Bulletin # PIB-5K-0204-001

PRODUCT INFORMATION BULLETIN

Ride Manufacturer:	Dartron Industries, Inc.	Affected Production Dates:	All Cliff Hangers
Ride Name:	Cliff Hanger	Affected Serial #'s:	All
Model #	All Cliff Hangers

PASSENGER CARRIER INSPECTION GUIDE

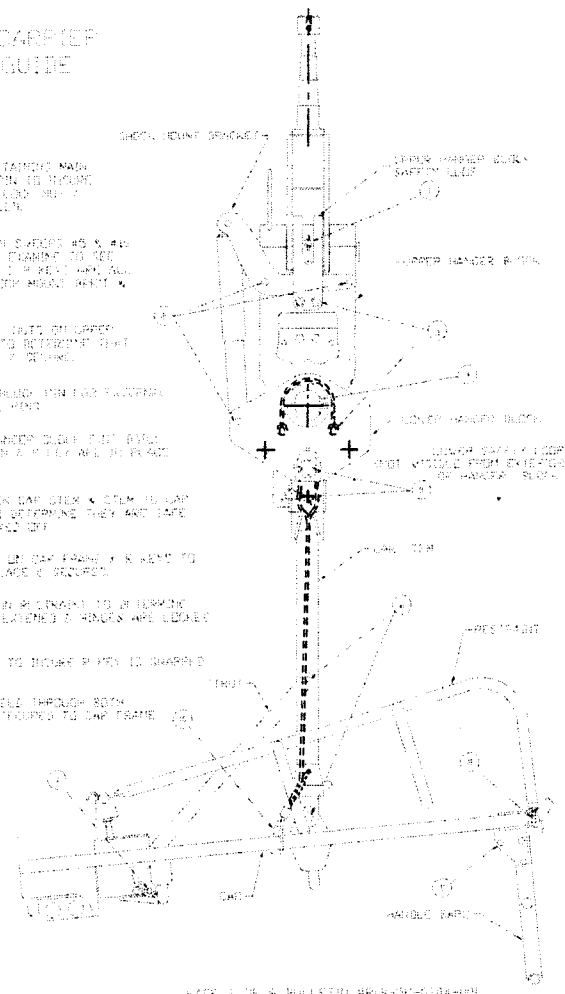
1. CHECK PASSENGERS RETAINING MAIN HANGER BLOCK. CHECK FOR 10 POINTS OF BOLT TORQUE. CHECK FOR DEFECTS AND REPAIRS.
2. CHECK LOWER BOWTIE OR SWAYBEAM AS APPLICABLE. CHECK FOR REMOVABLE PINS. EXAMINE TO SEE THAT PINS ARE CORRECT TYPE AND ALL INSTALLED IN CORRECT MOUNTING POINTS. LOWER HANGER BLOCK.

3. CHECK BOLTS & NUTS ON UPPER & LOWER HANGER BLOCKS TO BE CERTAIN THAT FASTENERS ARE INSTALLED CORRECTLY.
4. CHECK LOWER HANGER BLOCK FOR TWO FASTENERS BEHIND PIN & PULL POINT.

5. CHECK CAP STEM TO HANGER BLOCK FOR BUSH. CHECK FOR CRACKS. PIN & PULL WELD IN PLACE & BUSH NOT BROKEN OFF.
6. CHECK BUSHES TO FIT IN CAP STEM & STEM TO CAP BUSH. BUSHES MUST BE VERIFIED THAT ARE SAFE & NOT HAVE NOT BROKEN OFF.

7. CHECK CAP STEM WELD ON CAP FRAME & WELD TO HANGER BLOCK ARE IN PLACE & SECURED.
8. EXAMINE PIVOT POINT FOR REMAINS TO BE REMOVED. MAKE ALL CHECKS ARE SATISFACTORY. HINGERS ARE SECURED IN PLACE.

9. CHECK CAR HANDLE PIN TO INSURE PINS IS SHIPPED IN PLACE.
10. EMPTY CAR IS THREADED THROUGH BOTH TUBES OF CAP STEM & TIGHTEN TO CAP FRAME.
